March 14, 2001
CEOG-01-065

Subject: Transmittal of Approved Topical Report CE NPSD-1168-A, Rev 00

Joint Applications Report for Containment Isolation Valve AOT Extension

CE NPSPD-
1168-A, Rev 00

Figure 2: Schematic of Penetration Connected Directly to Containment Atmosphere and Outside Environment -- Penetration Path A1

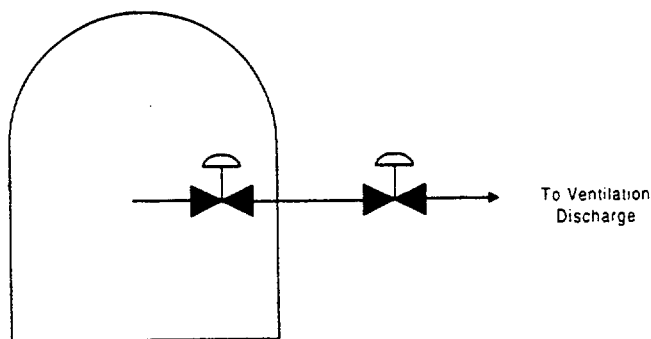
ID	Description of Penetration Flow Path	Calculation Method	Comment
A1	CIVs in penetrations connected directly to containment atmosphere and outside environment (See Figure 2)	<p>SINCE THE PIPING OUTSIDE CONTAINMENT IS OPEN, NO DIFFERENTIATION IS MADE BETWEEN SEISMIC AND NON-SEISMIC EVENTS</p> $SAOT_{LIRF} = \Delta CDF \cdot P_{CIV} \cdot \frac{AOT}{8760} = 8.8E-9$ <p>where</p> <p>$SAOT_{LIRF}$ = single AOT risk for large early release</p> <p>ΔCDF = change in CDF, baseline CDF assumed to be: $2E-4/yr$</p> <p>P_{CIV} = failure probability of unaffected CIV (solenoid type): $2.3E-3$</p> <p>$\frac{AOT}{8760}$ = fraction of full duration of AOT (i.e., 168 hours) to a year</p>	<p>Specific Assumptions:</p> <ul style="list-style-type: none"> Inoperability of one CIV is detected during periodic surveillance or cycling of the valve. The inoperable CIV is in the open position and the other CIV is the only barrier for releases to the environment. The failure mechanism causing the operable CIV to open also prevents it from closing if a demand occurs. <p>REVIEW COMMENTS:</p> <ul style="list-style-type: none"> The unaffected CIV is assumed to be OPERABLE. It is assumed that the cause of the failure of the affected CIV is not shared by the redundant CIV. That is, common cause failure is absent. The redundant valve is treated as same-as-new.

Figure 3: Schematic of Penetration Connected Directly to Containment Atmosphere and a Closed Loop System -- Penetration Path A2

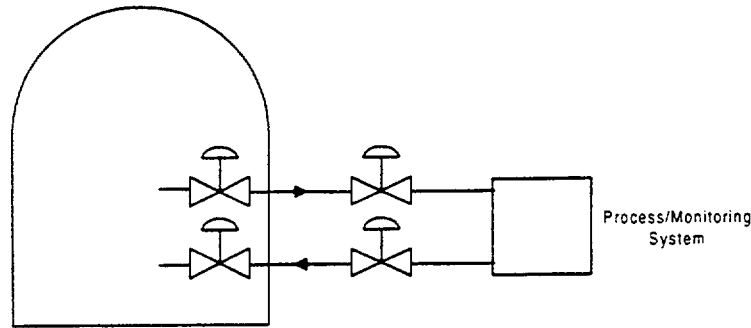
ID	Description of Penetration Flow Path	Calculation Method	Comment
A2	CIVs in penetrations connected directly to containment atmosphere and closed loop system outside environment (See Figure 3)	<p>NON-SEISMICALLY INITIATED EVENTS</p> $SAOT_{T_{LHR}} = ACDF \cdot P_{CIV} \cdot P_i \cdot \frac{AOT}{8760} = 1.5E-12$ <p>where</p> $SAOT_{T_{LHR}} = \text{single AOT risk for large early release}$ $ACDF = \text{change in CDF, baseline CDF assumed to be: } 2E-4/\text{yr}$ $P_{CIV} = \text{failure probability of unaffected CIV (air-operated): } 3.85E-3$ $P_i = \text{probability of a pipe failure in closed loop system: } 1E-4$ $\frac{AOT}{8760} = \text{fraction of full duration of AOT (i.e., 168 hours) to a year}$ <p>SEISMICALLY INITIATED EVENTS</p> $SAOT_{T_{LHR}} = ACDF \cdot P_{CIV} \cdot \frac{AOT}{8760} = 1.3E-9$ <p>where</p> $ACDF = \text{change in CDF, baseline CDF for seismic assumed to be: } 1.75E-4/\text{yr}$ $P_{CIV} = \text{same as above}$ $\frac{AOT}{8760} = \text{fraction of full duration of AOT (i.e., 168 hours) to a year}$	<p>Specific Assumptions:</p> <ul style="list-style-type: none"> CIVs normally opened and cycled to satisfy in-service testing and TS requirements. Inoperability of one CIV is detected during periodic surveillance or cycling of the valve and it is secured in open position when found to be inoperable. CIVs may be either AOVs or solenoid-operated valves. The inoperable CIV remains open for all conditions and demands. Conditional failure probability is 1 following a seismic event for non-seismic piping systems. <p>REVIEW COMMENTS:</p> <ul style="list-style-type: none"> The unaffected CIV is assumed to be OPERABLE. Crediting close loop system as a barrier is applicable to cases in which the affected valve (the valve under CM) is intact. If not true, the value of $SAOT_{T_{LHR}}$ of 1.5E-12 increases to 1.5E-8.

Figure 4: Schematic of Penetration Connected to Containment Atmosphere and an Open Loop System -- Penetration Path A3

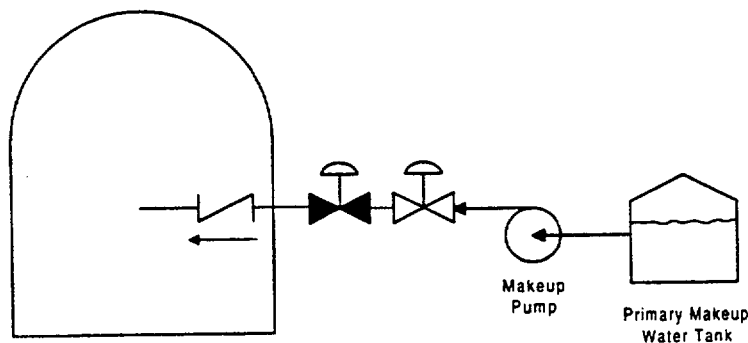
ID	Description of Penetration Flow Path	Calculation Method	Comment
A3	CIVs in penetrations connected directly to containment atmosphere and open loop system outside environment (See Figure 4)	<p>NON-SEISMICALLY INITIATED EVENTS</p> $SAOT_{LRF} = \Delta CDF \cdot P_{CK} \cdot P_n \frac{AOT}{8760} = 5.83E-13$ <p>where</p> <p>$SAOT_{LRF}$ = single AOT risk for large early release</p> <p>ΔCDF = change in CDF, baseline CDF assumed to be: 2E-4/yr</p> <p>P_{CK} = failure probability of unaffected CIV (check valve): 1.52E-3</p> <p>P_n = probability of a pipe failure in open loop system: 1E-4</p> <p>$\frac{AOT}{8760}$ = fraction of full duration of AOT (i.e., 168 hours) to a year</p> <p>SEISMICALLY INITIATED EVENTS</p> $SAOT_{LRF} = \Delta CDF \cdot P_{CK} \cdot \frac{AOT}{8760} = 5.1E-10$ <p>where</p> <p>ΔCDF = change in CDF, baseline CDF for seismic assumed to be: 1.75E-4/yr</p> <p>P_{CK} = same as above</p> <p>$\frac{AOT}{8760}$ = fraction of full duration of AOT (i.e., 168 hours) to a year</p>	<p>Specific Assumptions:</p> <ul style="list-style-type: none"> CIVs are check valve inside containment and AOV outside containment. Failure of a check valve is 1.52E-3 per demand. Inoperability of one CIV is detected during periodic surveillance or cycling of the valve and it is secured in open position when found to be inoperable. For outside containment, there are multiple valves for isolation of a break and failure of multiple valves is assumed to be a low probability event and has no impact. Pipe break cannot be isolated. Piping outside the containment is non-seismically qualified and probability of pipe failure after a seismic event is 1.0. <p>REVIEW COMMENTS:</p> <ul style="list-style-type: none"> The unaffected CIV is assumed to be OPERABLE. In this case although the loop is open, the analysis effectively assumes a closed loop system by crediting other means of isolation as shown in term P_n. As in the case of A2, crediting close loop system as a barrier is applicable to cases in which the affected valve (the valve under CM) is intact.

A3	CIVs associated with these flow paths isolate the containment in the event of an accident. CIVs in penetrations connected directly to containment atmosphere and open loop system outside environment. (See Figure 4)	A pipe break in an open-loop concurrent with a failure to isolate the containment penetration would establish a direct pathway to the environment (containment bypass).	Same as A1 above.	Failure of non-seismically qualified piping in the open-loop concurrent with an open CIV leads to containment bypass.
A4	CIVs associated with these flow paths isolate the containment in the event of an accident. CIVs in penetrations connected directly to closed loop system inside and outside containment. (See Figure 5)	A pipe break in a closed-loop system both inside and outside containment with failure to isolate the penetration would result in a direct pathway to the environment (containment bypass).	Same as A1 above.	Failure of non-seismically qualified piping in a closed-loop system both inside and outside containment concurrent with an open CIV leads to containment bypass.

Figure 5: Schematic of Penetration Connected to Closed Loop Inside and Outside Containment -- Penetration Path A4

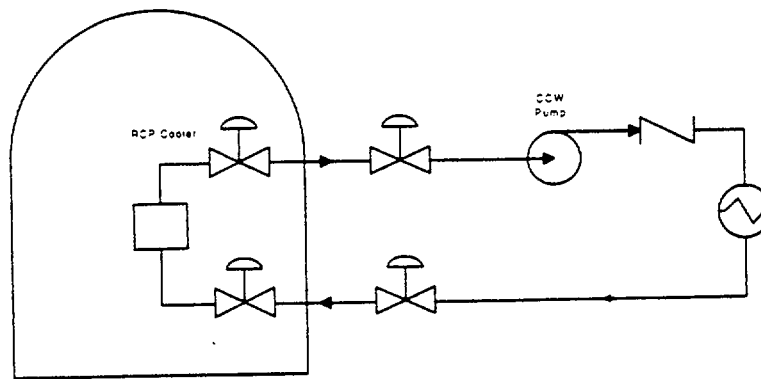
ID	Description of Penetration Flow Path	Calculation Method	Comment
A4	CIVs in penetrations connected directly to closed loop system inside and outside containment (See Figure 5)	<p>NON-SEISMICALLY INITIATED EVENTS</p> $SAOT_{ILRF} = ACDF \cdot P_{CIV} \cdot P_{in} \cdot P_{ro} \cdot \frac{AOT}{8760} < 2E-13$ <p>where</p> <p>$SAOT_{ILRF}$ = single AOT risk for large early release</p> <p>$ACDF$ = change in CDF, baseline CDF assumed to be: $2E-4/yr$</p> <p>P_{CIV} = failure probability of unaffected CIV (air-operated): $3.85E-3$</p> <p>P_{in} = probability of a pipe failure in close loop system inside containment: $1E-4$</p> <p>P_{ro} = probability of a pipe failure or inadvertent opening of a relief valve in closed loop outside containment: $6E-4$</p> <p>$\frac{AOT}{8760}$ = fraction of full duration of AOT (i.e., 168 hours) to a year</p> <p>FOR SEISMICALLY INITIATED EVENTS</p> $SAOT_{ILRF} = ACDF \cdot P_{CIV} \cdot \frac{AOT}{8760} = 1.3E-9$ <p>where</p> <p>$ACDF$ = change in CDF, baseline CDF for seismic assumed to be: $1.75E-4/yr$</p> <p>P_{CIV} = same as above</p> <p>$\frac{AOT}{8760}$ = fraction of full duration of AOT (i.e., 168 hours) to a year</p>	<p>Specific Assumptions:</p> <ul style="list-style-type: none"> Inoperability of one CIV is detected during periodic surveillance of the valve and it is secured in open position when found to be inoperable. Piping (inside and outside) is non-seismically qualified and has a conditional failure probability of 1.0 for seismic events. A breach in the piping of both inside and outside containment must fail concurrently with failure to isolate the penetration for a pathway to the environment. Inadvertent opening of a relief valve will also breach the piping outside of containment and is given a probability of $5.0E-4$ for the proposed AOT. AOV failure probability includes failure of the valve to close on demand or to remain closed during the proposed AOT. <p>REVIEW COMMENTS:</p> <ul style="list-style-type: none"> The unaffected CIV is assumed to be OPERABLE. Crediting close loop system outside containment as a barrier is applicable to cases in which the affected valve (the valve under CM) is intact. If not true, the value of $SAOT_{ILRF}$ would increase by a factor of $1.0E4$.

Figure 6: Schematic of Penetration Connected to SI Line Leakage Path -- Penetration Path B1

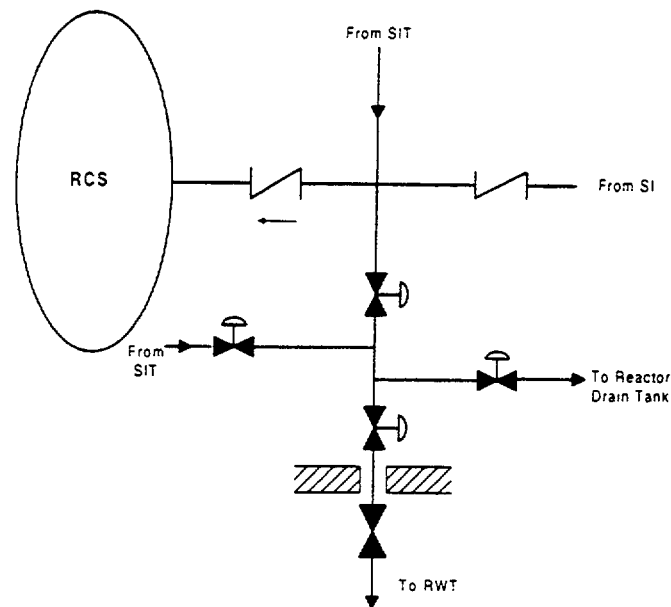
ID	Description of Penetration Flow Path	Calculation Method	Comment
B1	CIVs in penetrations connected to Safety Injection (SI) line check valve leakage path (See Figure 6)	$ISLOCA = \frac{\lambda_1 \lambda_2 \lambda_3 T^2}{3} + \lambda_1 \lambda_2 \lambda_3 \left[\frac{d_2 T + 1}{2} \right] + \lambda_1 \lambda_2 \lambda_3 T \left[\frac{d_3 T + 1}{2} \right]$ $+ 2 \lambda_1 \lambda_2 \lambda_3 \left[\frac{d_2 T + 1}{2} \right] \left[\frac{d_3 T + 1}{2} \right] = 2.19E-8 \text{ per year}$ $SAOT_{IER} = ISLOCA * \frac{AOT}{8760} = 4.19E-10$ <p>where,</p> <p>$SAOT_{IER}$ = single AOT risk for large early release</p> <p>$ISLOCA$ = frequency of interfacing system LOCA per year: 2.19E-8 per year</p> <p>λ_1 = random leakage rate of SI check valve: 8.76E-4 per year</p> <p>λ_2 = random leakage rate of AOV: 7.0E-3 per year</p> <p>λ_3 = random leakage rate of manually operated valve: 1.68E-3 per year</p> <p>λ_{d2} = probability of the AOV failing to reseal: 1.55E-3 per demand</p> <p>λ_{d3} = probability of the manually operated valve failing to reseal: 3.88E-4 per demand</p> <p>d_2 = the number of times the AOV is operated: 4</p> <p>d_3 = the number of times the manually operated valve is operated: 4</p> <p>T = fault exposure time: 1 year</p> <p>$\frac{AOT}{8760}$ = fraction of full duration of AOT (i.e., 168 hours) to a year</p>	<p>Specific Assumptions:</p> <ul style="list-style-type: none"> Assumed that penetration has one AOV on inside and one manually operated valve on outside the containment. The inoperability of the AOV is detected during surveillance or cycling of the valve. The failure mode of manually operated valves is not known but failure to reseal is bounded by a failure on demand of 3.88E-4 per demand. Average of four in-service tests of the manual CIV per year. Mean failure rate of an AOV transferring open is 7.98E-7 per hour and a bounding probability to fail on demand of 1.55E-3. The AOV is cycled once per quarter. Random leakage of a SI check valve is assumed to be 8.76E-4. Fault exposure time is equivalent to time that the plant operates in its non-cold shutdown modes, namely one year. A pressure transmitter can detect a leaking or stuck open SI check valve. <p>REVIEW COMMENTS:</p> <ul style="list-style-type: none"> The unaffected CIV is assumed to be OPERABLE. Without taking credit of the pressure transmitter, the result can change significantly. It appears that the expression used to estimate ISLOCA frequency is unnecessary complex. Verification of the correctness of the equation was not performed. It is recommended that the applicant fully derive the equation presented and provide additional discussion. The expression used in the JAR does not account for common cause failure of redundant valves.

B1	CIVs associated with these flow paths isolate the containment in order to minimize the leakage of reactor coolant. CIVs in penetrations connected to safety injection (SI) line check valve leakage path. (See Figure 6)	Failure of multiple barriers would result in over-pressurization of low pressure piping outside containment. Over-pressurization could lead to an interfacing system LOCA. A failed CIV inside containment reduces the number of barriers to protect the low pressure system.	The loss of reactor coolant to the low pressure piping outside containment impacts the effectiveness of ECCS.	Failure of the low pressure piping outside containment creates a direct leakage path for radioactive materials to the environs (containment bypass).
B2	CIVs associated with these flow paths isolate the containment in order to minimize the leakage of reactor coolant. CIVs in penetrations connected to the reactor coolant system (RCS) sample line. (See Figure 7)	CIV failure mode could lead to discharge of reactor coolant given a failure of non-seismically qualified piping outside containment.	Small impact expected for this event due to line size and ECCS make-up capability.	An inoperable and open CIV in conjunction with non-seismic piping failure would lead to a direct leakage path for radioactive materials to the environs.

Figure 7: Schematic of Penetration Connected to RCS Sample Line -- Penetration Path B2

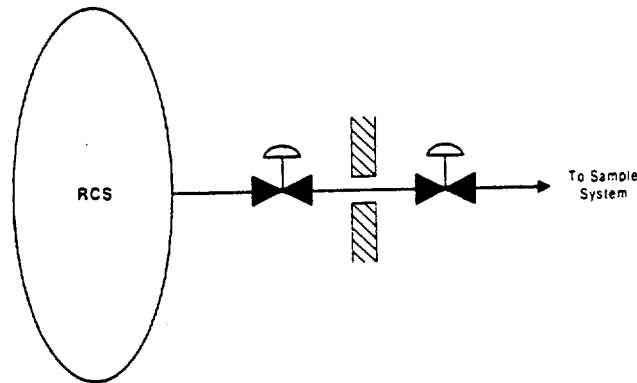
ID	Description of Penetration Flow Path	Calculation Method	Comment
B2	CIVs in penetrations connected to the reactor coolant system (RCS) sample line (See Figure 7)	$SAOT_{LIRI} = CDDP_{SL} * F_P * P_{IRC} * \frac{AOT}{8760} = 8.23E-10$ <p>where,</p> <p>$SAOT_{LIRI}$ = single AOT risk for large early release</p> <p>$CDDP_{SL}$ = total conditional core damage probability given the interaction of a small LOCA: $3.7E-3$</p> <p>F_P = frequency of a random pipe failure occurring in the sample system creates a small LOCA: $5.0E-3$ per year</p> <p>P_{IRC} = probability of the operable CIV failing to remain closed during the proposed AOT: $2.3E-3$</p> <p>$\frac{AOT}{8760}$ = fraction of full duration of AOT (i.e., 168 hours) to a year</p> <p>FOR SEISMIC EVENTS:</p> <p>$SAOT_{LIRI} = 6.57E-10$</p>	<p>Specific Assumptions:</p> <ul style="list-style-type: none"> Both CIVs are AOVs. CIVs assumed to be cycled daily and initially closed. Probability to remain closed is more conservative than failing to close on demand. The same failure mechanism causing the CIV to transfer open prevents it from closing on demand. Pipe failure due to exposure to high RCS temperature and pressure is negligible. A break in the sample system can be compensated by charging system or ECCS and the plant can be shutdown in a timely manner so it will not lead to core damage. Note: $CDDP_{SL} * F_P$ is equivalent to core damage frequency associated with a sample system pipe failure ($1.9E-5$). Assumed exposure time used for P_{IRC} is equal to AOT. This assumption is not conservative. The exposure time should be the time between the last test to the end of AOT. <p>REVIEW COMMENTS:</p> <ul style="list-style-type: none"> The unaffected CIV is assumed to be OPERABLE. It is assumed that the cause of the failure of the affected CIV is not shared by the redundant CIV. That is, common cause failure is absent. The redundant valve is treated as same-as-new.

Figure 8: Schematic of Penetration Connected to Letdown Line -- Penetration Path B3

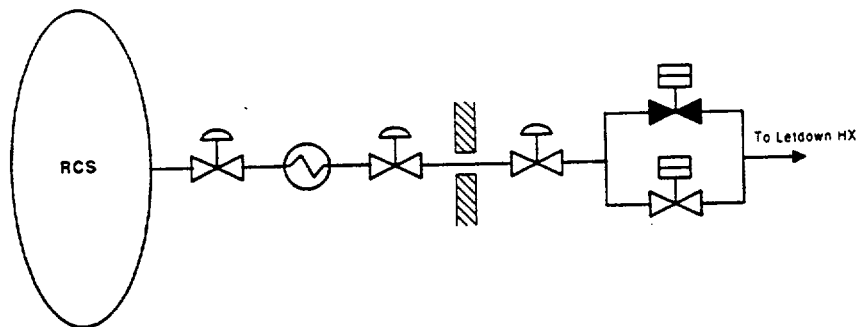
ID	Description of Penetration Flow Path	Calculation Method	Comment
B.3	CIVs in penetrations connected to Letdown or reactor coolant pump (RCP) bleed-off line (See Figure 8)	<p>BREAK INSIDE CONTAINMENT:</p> $SAOT_{LIRF} = ICCDP * P_{FIC}$ $= \left[CCDP_M * F_P * P_{FIC} * \frac{AOT}{8760} \right] * P_{FIC}$ $= (5.54E-10) * (1.55E-3) = 8.59E-13$ <p>BREAK OUTSIDE CONTAINMENT:</p> $SAOT_{LIRF} = ICCDP = F_P * P_N * \frac{AOT}{8760}$ $= 7.82E-9$ <p>where</p> <p>$SAOT_{LIRF}$ = single AOT risk for large early release</p> <p>$ICCDP$ = incremental conditional core damage probability</p> <p>$CCDP_M$ = total conditional core damage probability given the interaction of a small LOCA: 3.73E-3</p> <p>F_P = frequency of a random pipe failure occurring in the letdown line inside or outside containment: 5.0E-3/yr for inside and 2.63E-3/yr for outside</p> <p>P_{FIC} = probability of the remaining CIVs failing to closed by common cause during the proposed AOT: 1.55E-3</p> <p>P_N = probability of both CIVs failing to closed during the proposed AOT: 1.55E-4</p> <p>$\frac{AOT}{8760}$ = fraction of full duration of AOT (i.e., 168 hours) to a year</p>	<p>Specific Assumption:</p> <ul style="list-style-type: none"> All valves are AOVs and AOV failure to close is 1.55E-3. Failure of the actuation signal to close the AOV is negligible when compared with hardware failures. Inoperability of one CIV can be detected and secured in open position. The two other AOVs can isolate the containment. Break is assumed between the two CIVs inside containment and the one downstream of the regenerative heat exchanger is inoperable and in the open position. Breach in outside line is downstream of the outside CIV from piping failure or failure of a relief valve (probability of 2.13E-2 per year). The probability of both operable CIVs failing to close is dominated by common cause failure for a probability of 1.55E-4. <p>REVIEW COMMENTS:</p> <ul style="list-style-type: none"> In the text, the equation for a break outside containment has CLERP not ICLERP. This is assumed to be a typo. The unaffected CIV is assumed to be OPERABLE. For this situation, the licensee may be able to enter the LCO by removing two CIVs. It is recommended that guidance be provided that only one CIV of a pair could be removed at a time.

Figure 9: Schematic of Penetration Connected to Non-Essential Cooling Units -- Penetration Path C1

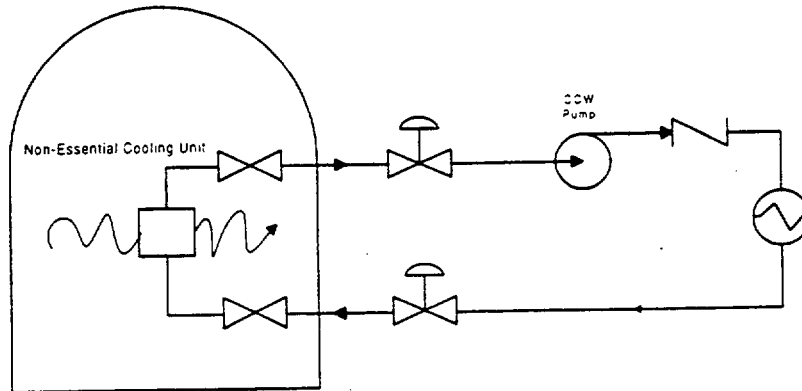
ID	Description of Penetration Flow Path	Calculation Method	Comment
CI	CIVs in penetrations connected to non-essential containment cooling (See Figure 9)	<p>CASE INVOLVING A RANDOM PIPE FAILURE AND CAUSING REACTOR SCRAM:</p> $SAOT_{CDF} = ICCDP \cdot F_r \cdot \frac{AOT}{8760}$ $= 3.07E-9$ $SAOT_{LRR} = ICCDP \cdot P_R$ $= 1.84E-12 \text{ (without } P_f \text{)}$ <p>CASE INVOLVING A PIPE FAILURE CONCURRENT WITH CORE DAMAGE:</p> $SAOT_{LRR} = ACDF \cdot P_f \cdot P_R \cdot \frac{AOT}{8760}$ $= 2.30E-13$ <p>where</p> <p>$SAOT_{CDF}$ = single AOT risk for core damage</p> <p>$SAOT_{LRR}$ = single AOT risk for large early release</p> <p>$CCDP_f$ = conditional core damage probability due to reactor trip: $6.08E-6$</p> <p>$ICCDP$ = incremental conditional core damage probability</p> <p>$ACDF$ = change in CDF, baseline CDF assumed to be: $2E-4/yr$</p> <p>F_r = frequency of breaching a closed loop system outside the containment: $2.63E-2$ per year</p> <p>P_f = probability of a pipe failure in the closed loop system inside the containment: $1.0E-4$</p> <p>P_R = probability of a pipe failure in the closed loop system outside the containment: $6.0E-4$</p> <p>$\frac{AOT}{8760}$ = fraction of full duration of AOT (i.e., 168 hours) to a year</p>	<p>Specific Assumptions:</p> <ul style="list-style-type: none"> One AGV per penetration and is open during normal operation. Inadvertent opening of a relief valve will also breach the piping outside of containment and is given a probability of $5.0E-4$ for the proposed AOT. The combination of relief and piping failure yield a probability of $6.0E-4$. A breach in the piping of both inside and outside containment must fail for a pathway to the environment. <p>REVIEW COMMENTS:</p> <ul style="list-style-type: none"> The equation for the case involving a pipe failure and causing reactor scram may need to have a probability for pipe failure outside containment to complete the pathway to the environment (P_f). The unaffected CIV is assumed to be OPERABLE. A breach in the closed loop system during power operation is assumed to cause an uncomplicated reactor trip. The presented analysis is valid if the breach does not impact the CCW function.

Figure 10: Schematic of Penetration Connected to Steam Generator -- Penetration Path C2

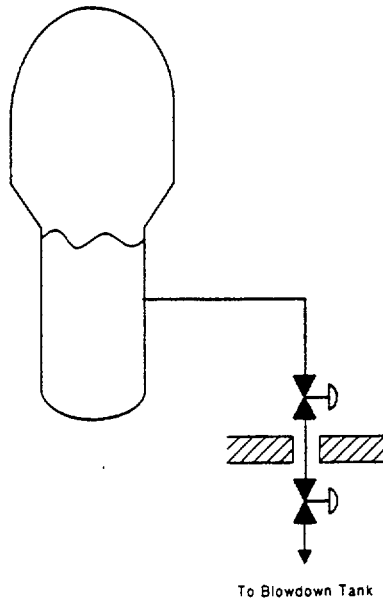
ID	Description of Penetration Flow Path	Calculation Method	Comment
C2	CIVs in penetrations connected to secondary side of steam generator (See Figure 10)	$SAOT_{LIR} = CCDP_{SGTR} * P_{TRC} * F_R * \frac{AOT}{8760}$ $= 2.02E-10$ <p>where</p> <p>$SAOT_{LIR}$ = single AOT risk for large early release</p> <p>$CCDP_{SGTR}$ = conditional core damage probability due to SGTR: 9.16E-4</p> <p>P_{TRC} = probability of the operable CIV failing to remain closed during the proposed AOT: 2.3E-3</p> <p>F_R = random pipe failure of blowdown piping outside the containment: 5.0E-3 per year</p> <p>$\frac{AOT}{8760}$ = fraction of full duration of AOT (i.e., 168 hours) to a year</p>	<p>Specific Assumptions:</p> <ul style="list-style-type: none"> A penetration has two closed AOVs and once one is determined inoperable, it is secured open. For a path to the environment, a SGTR event must also occur concurrently with a transfer opening of the closed CIV. The piping outside of the containment is non-seismically qualified. <p>REVIEW COMMENTS:</p> <ul style="list-style-type: none"> The unaffected CIV is assumed to be OPERABLE. It is assumed that the cause of the failure of the affected CIV is not shared by the redundant CIV. That is, common cause failure is absent. The redundant valve is treated as same-as-new.

C2	CIVs associated with these flow paths isolate the containment in the event of an accident. CIVs in penetrations connected to secondary side of steam generator. (See Figure 10)	Failed CIV to isolate a steam generator with a ruptured steam generator tube allows a release of reactor coolant outside containment through failed non-seismically qualified piping or an open safety-relief valve.	An open CIV in this case has the potential to impact CDF due to loss of coolant outside containment.	Direct pathway to environs would be created in the event of a CIV in the open position and a SG tube rupture event.
D	CIVs in these flow paths are designed to open during power operation and provide input to ESFS; designed to open during post accident conditions. CIVs in penetrations connected to containment atmosphere pressure detector. (See Figure 11)	CIV failure in the open position in a containment sensor line would create a direct path to the environs (containment bypass) should the sensor also fail.	No impact on CDF would result with a failed or open CIV.	An accident occurring with a failed or open CIV would not of itself create bypass leakage path to the environs. However, in conjunction with a concurrent failed sensor, a direct leakage path to the environs (containment bypass) would be created.

Figure 11: Schematic of Penetration Connected to Containment Instrument Sensor -- Penetration Path D

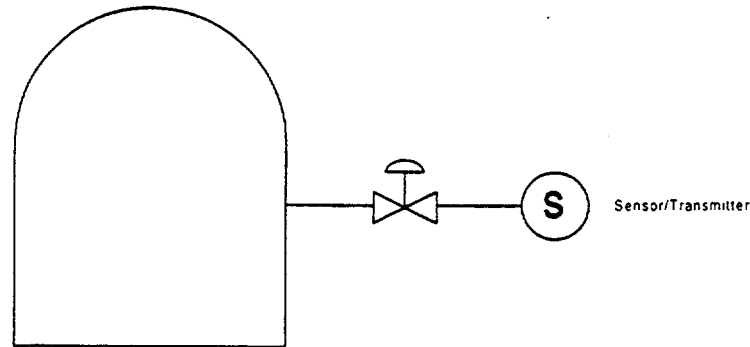
ID	Description of Penetration Flow Path	Calculation Method	Comment
D	CIVs in penetrations connected to containment atmosphere pressure detector (See Figure 11)	No equations, qualitative assessment	Proposed by CEOG to be negligible and well below acceptance criteria of 5.0E-7 and 5.0E-8 for ICCDP and ICERLP respectively.
E1	CIVs in penetrations used to support RCS inventory control safety function under accident condition (See Figure 12)	<p>HPS/LPSI LINE:</p> $ISLOCA = \frac{\lambda^2 T}{2} + \lambda \lambda_d \left[\frac{dT + 1}{2} \right]$ $SOAT_{LIRF} = ISLP = ISLOCA \cdot P_C \cdot \frac{AOT}{8760}$ $= 1.68E-9$ <p>where</p> <p>$SAOT_{LIRF}$ = single AOT risk for large early release</p> <p>$ISLP$ = incremental conditional ISLOCA probability</p> <p>$ISLOCA$ = frequency of interfacing system LOCA per year: 8.76E-7</p> <p>λ = random leakage rate of SI check valve: 8.76E-4 per year</p> <p>λ_d = probability of the second check valve failing to reseal: 2.81E-4 per demand</p> <p>d = the number of times the check valve is operated: 3</p> <p>P_C = conditional probability of pipe failure following exposure to RCS pressure: 0.1</p> <p>T = fault exposure time: 1 year</p> <p>$\frac{AOT}{8760}$ = fraction of full duration of AOT (i.e., 168 hours¹) to a year</p>	<p>Specific Assumptions:</p> <ul style="list-style-type: none"> Assumed that penetration has two check valves on inside and one MOV on outside the containment. The inoperability of the MOV is detected during surveillance or cycling of the valve. Piping upstream of the MOV can fail if exposed to RCS pressure with a conditional probability of 0.1. A pressure transmitter can detect a leaking or stuck open SI check valve. Random leakage of a SI check valve is assumed to be 8.76E-4. Average of three cold-shutdowns per year where the SI check valves are operated. Fault exposure time is equivalent to time that the plant operates in its non-cold shutdown modes, namely one year. <p>REVIEW COMMENTS:</p> <ul style="list-style-type: none"> Without taking credit of the pressure transmitter, the result can change significantly. It appears that the expression used to estimate ISLOCA frequency is unnecessary complex. Verification of the correctness of the equation was not performed. It is recommended that the applicant fully derive the equation presented and provide additional discussion. In this case although the loop is open, the analysis effectively assumes a closed loop system by crediting other means of isolation as shown in term P_C. Crediting close loop system as a barrier is applicable to cases in which the affected valve (the valve under CM) is intact.

Figure 13: Schematic of Penetration Connected to Charging Line -- Penetration Path E2

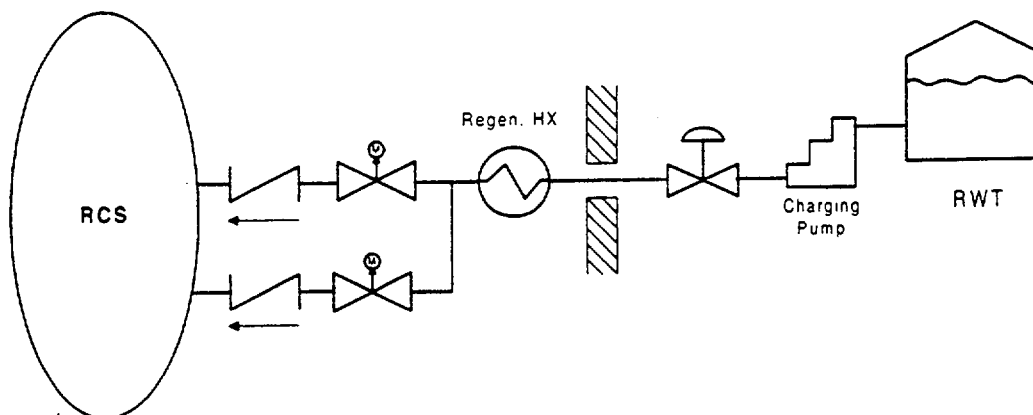
ID	Description of Penetration Flow Path	Calculation Method	Comment
E2	CIVs in penetrations used to provide charging under normal condition (See Figure 13)	No equations, qualitative assessment	Proposed by CEOG to be negligible and well below acceptance criteria of 5.0E-7 and 5.0E-8 for ICCDP and ICERLP respectively.
E3	CIVs in penetrations used to support containment heat removal function using containment sprays (See Figure 14)	$SAOT_{LIRF} = ACDF \cdot P_{CK} \cdot P_R \cdot \frac{AOT}{8760}$ $= 5.83E-13$ <p>where</p> <p>$SAOT_{LIRF}$ = single AOT risk for large early release</p> <p>$ACDF$ = change in CDF, baseline CDF assumed to be: 2E-4/yr</p> <p>P_{CK} = probability of a pipe failing to isolate the associated containment penetration: 1.52E-3</p> <p>P_R = probability of a pipe failure in the open loop system outside the containment: 1.0E-4</p> <p>$\frac{AOT}{8760}$ = fraction of full duration of AOT (i.e., 168 hours) to a year</p>	<p>Specific Assumptions:</p> <ul style="list-style-type: none"> The containment penetration has one MOV outside and a check valve inside the containment where the MOV is the CIV that fails and is secured in the open position. Based on the previous assumption, a redundant means of isolating the containment will be lost during the AOT of 7 days. Random pipe failure outside the containment leads to the unavailability of the affected train of containment spray and a potential pathway to the environment. Mean probability of a check valve to close is 1.52E-3. <p>REVIEW COMMENTS:</p> <ul style="list-style-type: none"> In this case although the loop is open, the analysis effectively assumes a closed loop system by crediting other means of isolation as shown in term P_R. As in the case of E1, crediting close loop system as a barrier is applicable to cases in which the affected valve (the valve under CM) is intact.
